Re: Source Materials License SUA-1534
Docket No. 40-8943
Mine Unit 1 Restoration; Response to Request For Additional Information

**Crow Butte Resources, Inc.
Response to U.S. Nuclear Regulatory Commission
Request For Additional Information**

Mine Unit 1 Groundwater Restoration Completion

Crow Butte Uranium Project

Mine Unit 1 Calcium Trend

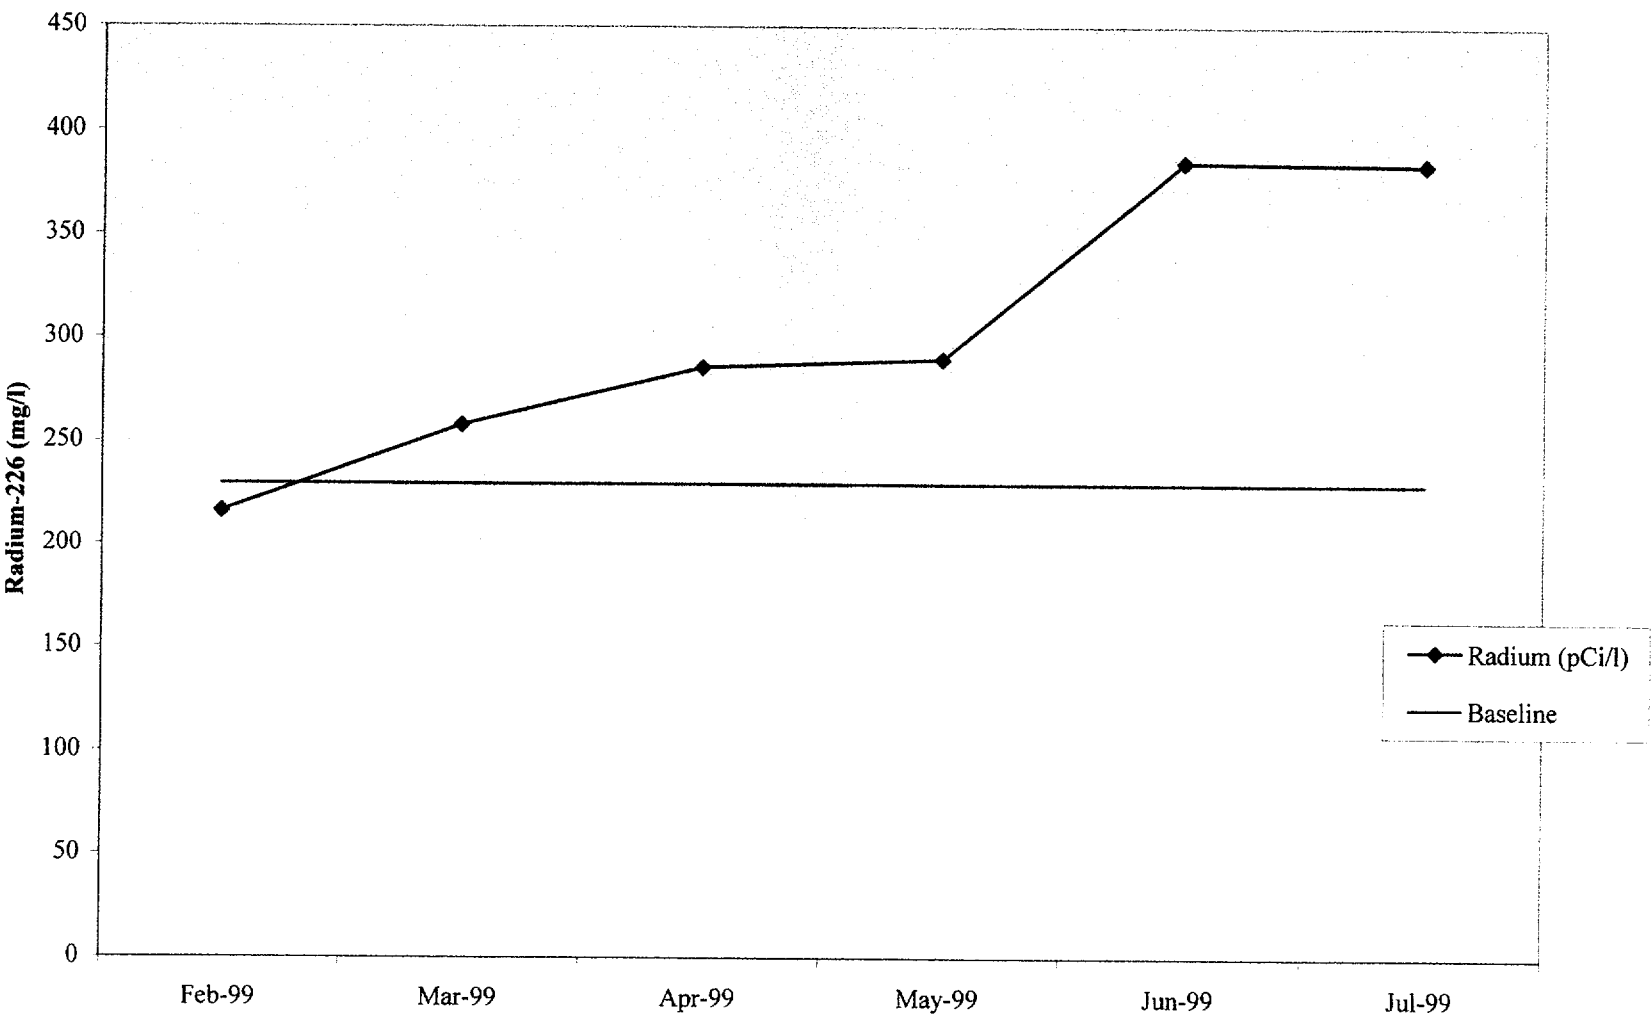
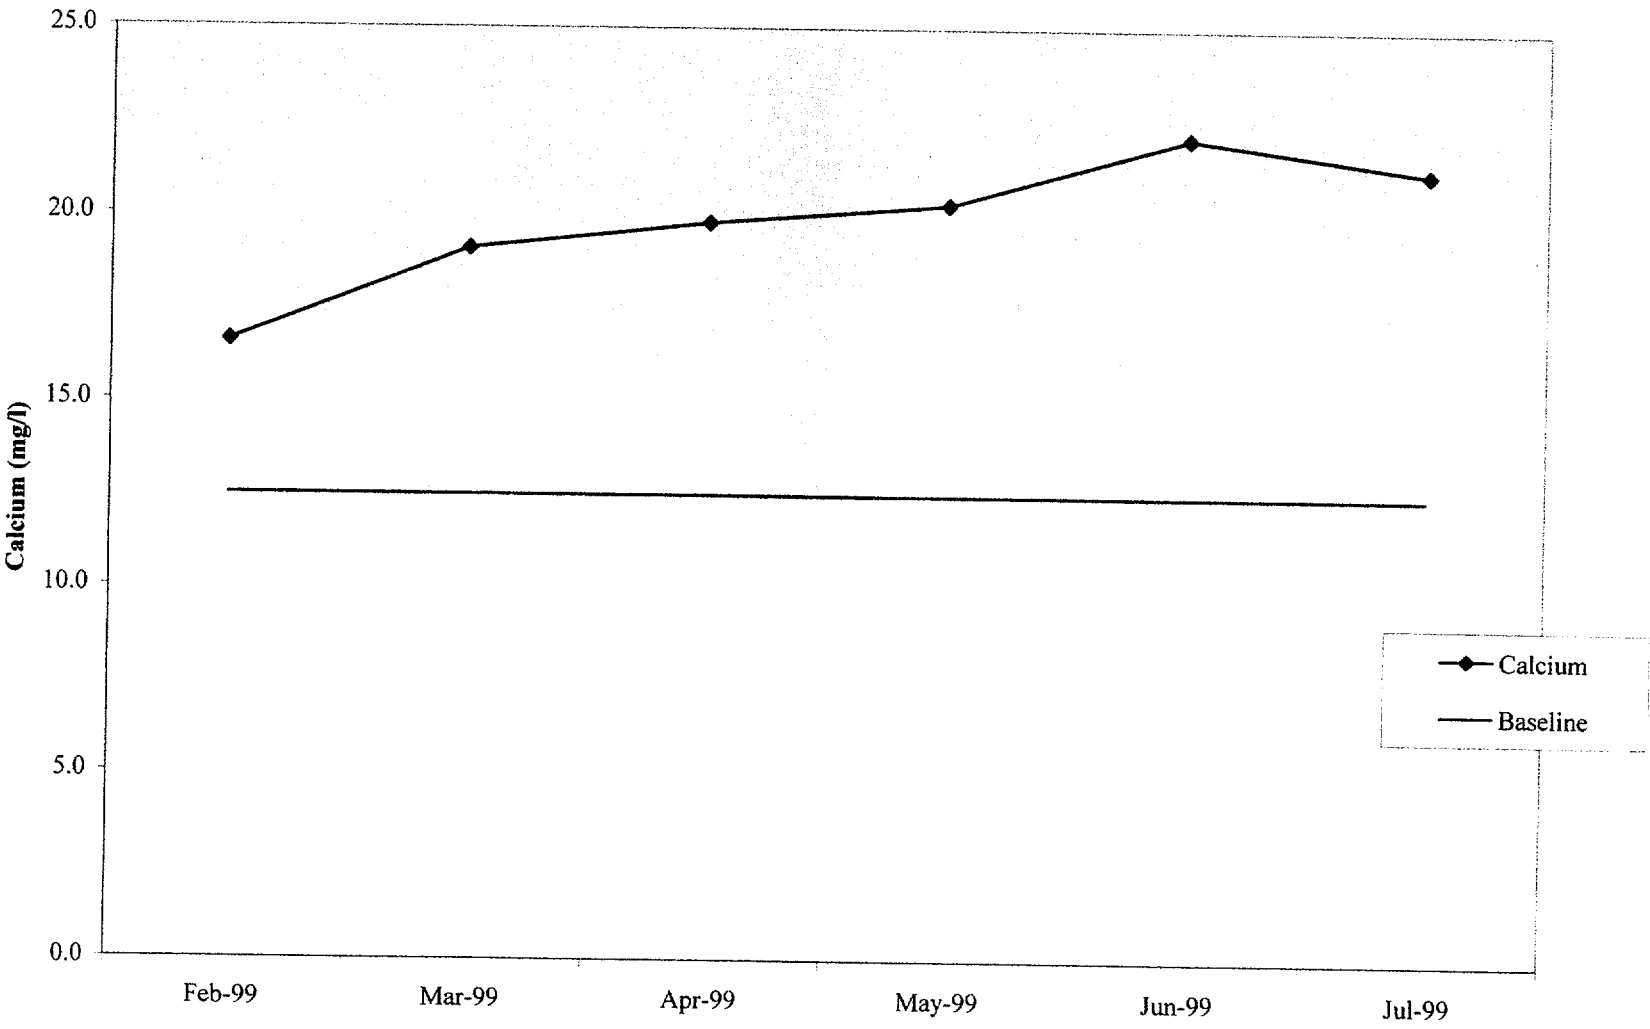
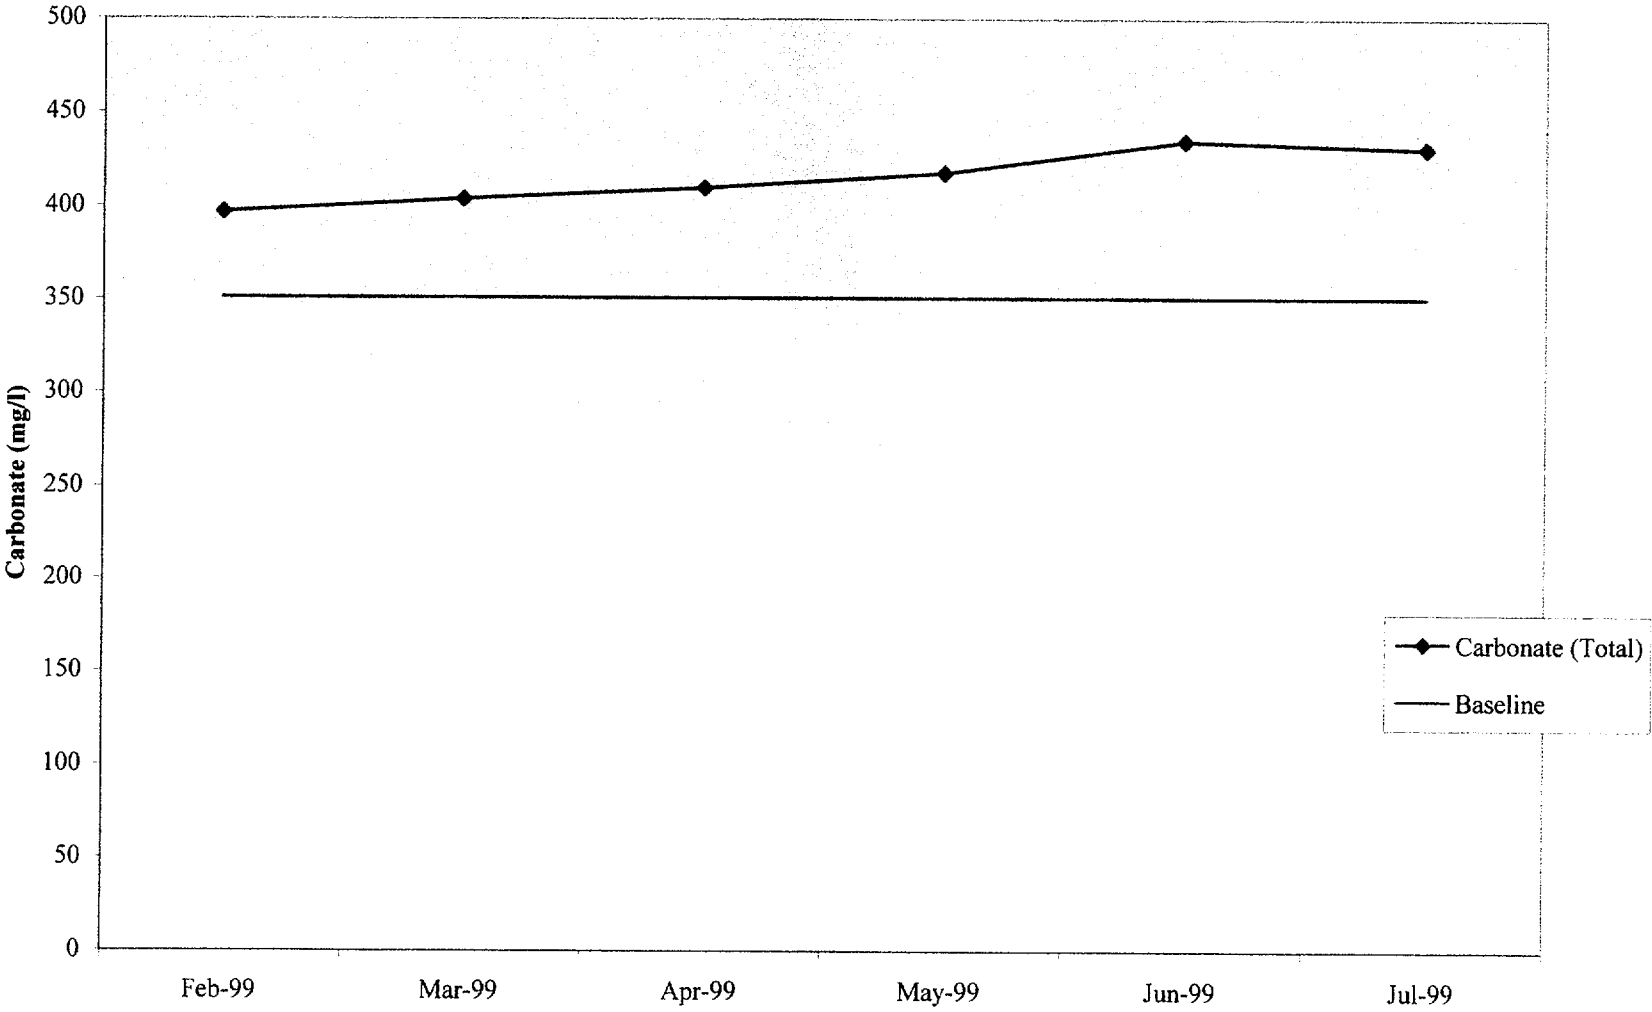
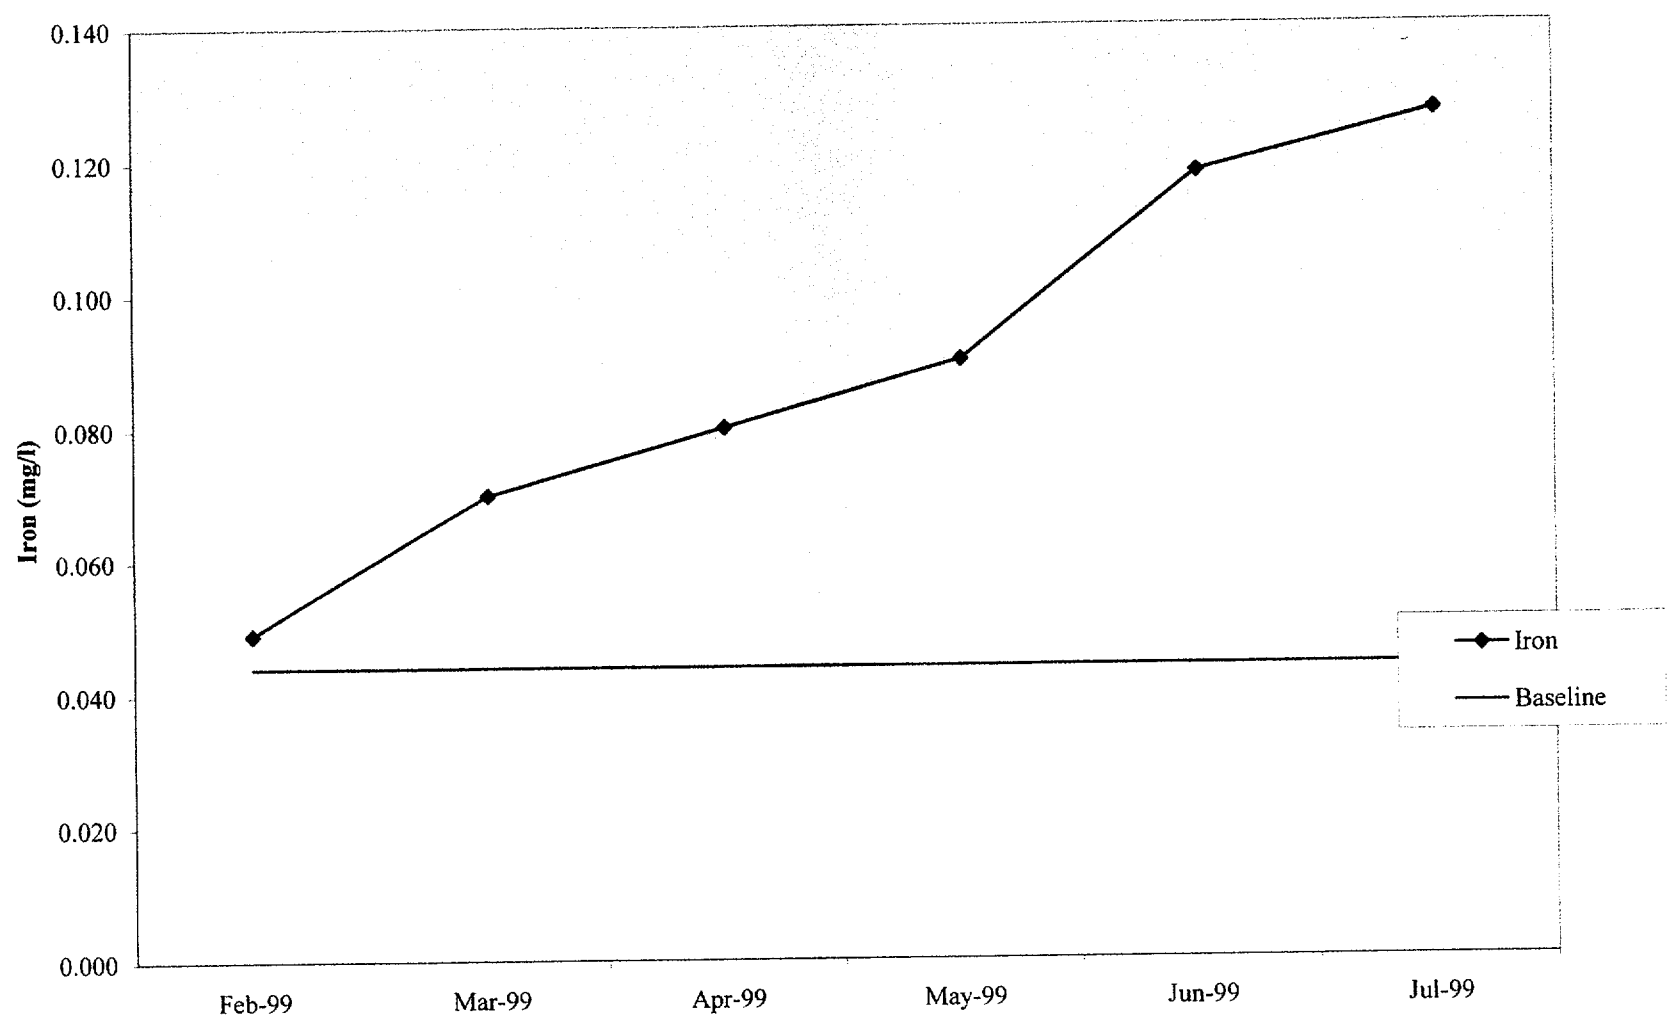
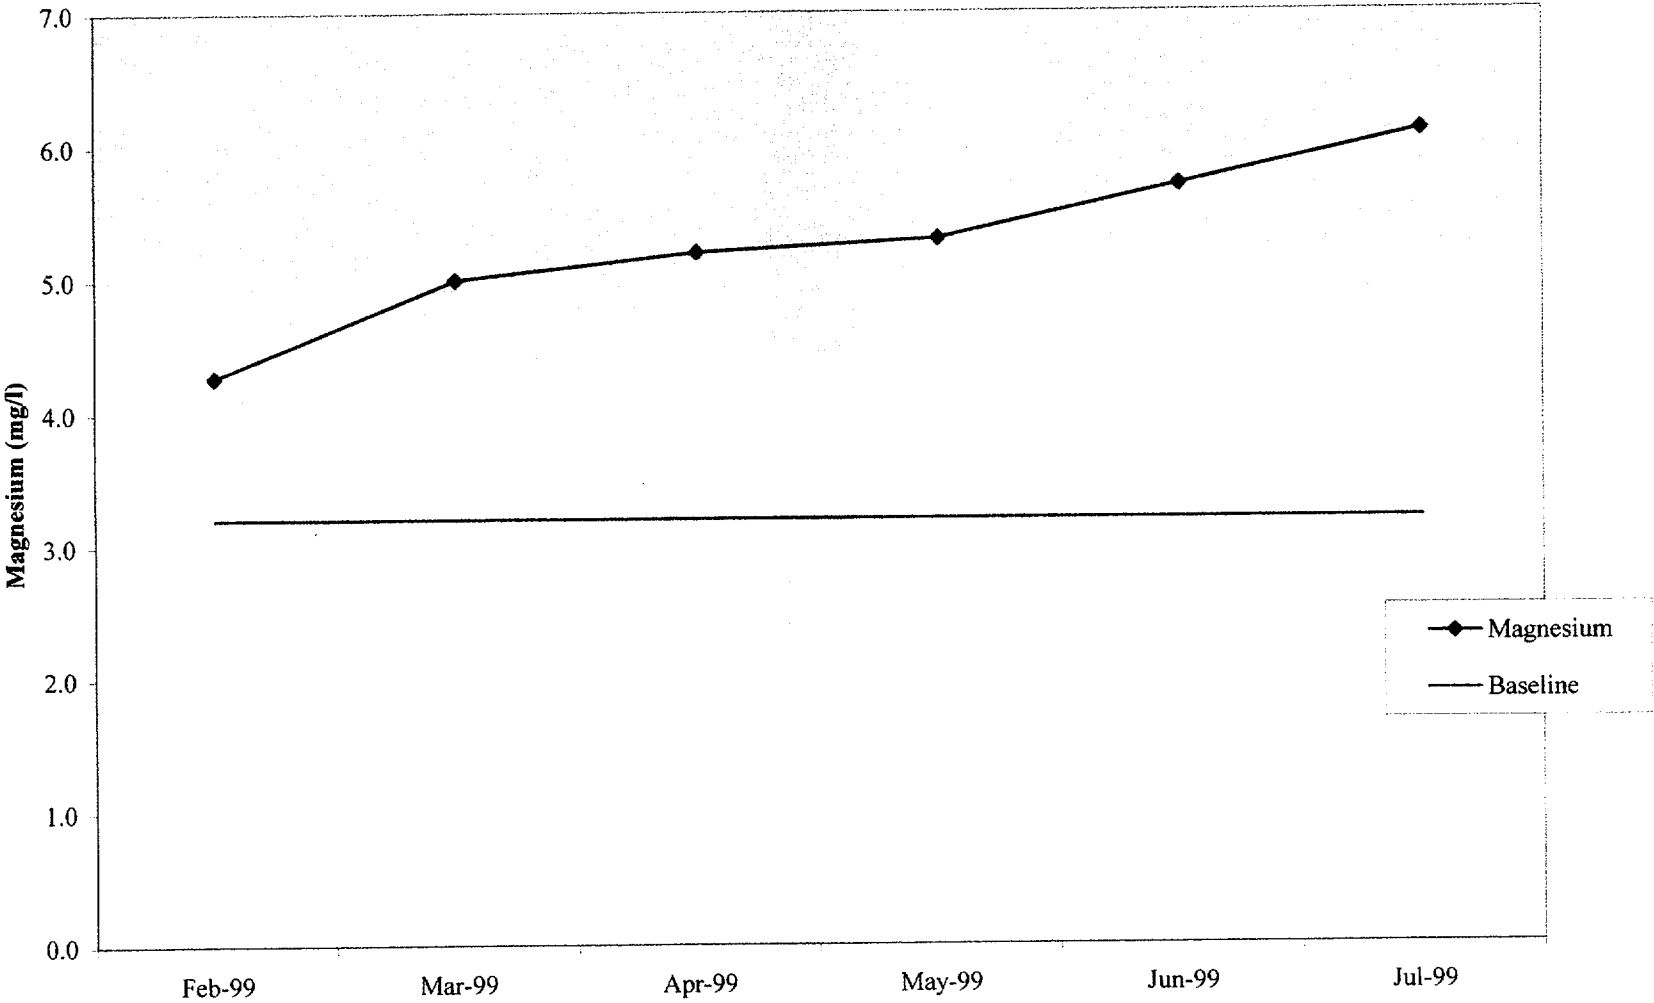
The NRC noted "strongly increasing" trends in a number of restoration parameters during the six month stabilization period. Specifically, NRC noted increasing trends in uranium, carbonate, potassium, radium-226, calcium, ammonium, chloride, iron, magnesium, manganese, molybdenum, sodium, sulfate, and total dissolved solids. In NRC's opinion, these trends could indicate that Mine Unit 1 was not stable during the stabilization monitoring period. NRC requested the following information to support CBR's position that Mine Unit 1 is stable.

Appendix A contains trend graphs from the stabilization period for all fourteen parameters identified by NRC. The graphs include a reference line for the average baseline concentration of the parameter. A review of these graphs indicates that most parameters do not exhibit a significant increasing trend, particularly when the final sample results are considered. Of the fourteen parameters listed by NRC, eleven showed no change or a significant decrease in the final stabilization sample. Only three parameters (ammonia, iron and magnesium) exhibited an increasing trend throughout the stabilization period.

- Ammonia was restored to concentrations below baseline. The final sample was 0.18 mg/l, or approximately 50 percent of the baseline concentration of 0.37 mg/l. It should be expected that ammonia concentrations would increase until natural background concentrations are restored.

- Iron exhibits a strong trend throughout the stabilization period, increasing from 0.049 to 0.127 mg/l. However, restoration successfully reduced iron to concentrations well below the secondary restoration goal. The final sample was 0.127 mg/l, or 42 percent of the restoration standard of 0.30 mg/l, which is based on the EPA Secondary Drinking Water Regulations (SDWR).
- Magnesium increased from 4.3 to 6.1 mg/l during the stabilization period. However, restoration successfully reduced magnesium to concentrations well below the secondary restoration goal. The final sample was 6.1 mg/l, or 19 percent of the restoration standard of 32 mg/l. Note that there are no EPA or NDEQ numerical standards for magnesium. The restoration standard is based upon one order of magnitude above baseline concentrations due to the ability of some major ions to vary with pH.
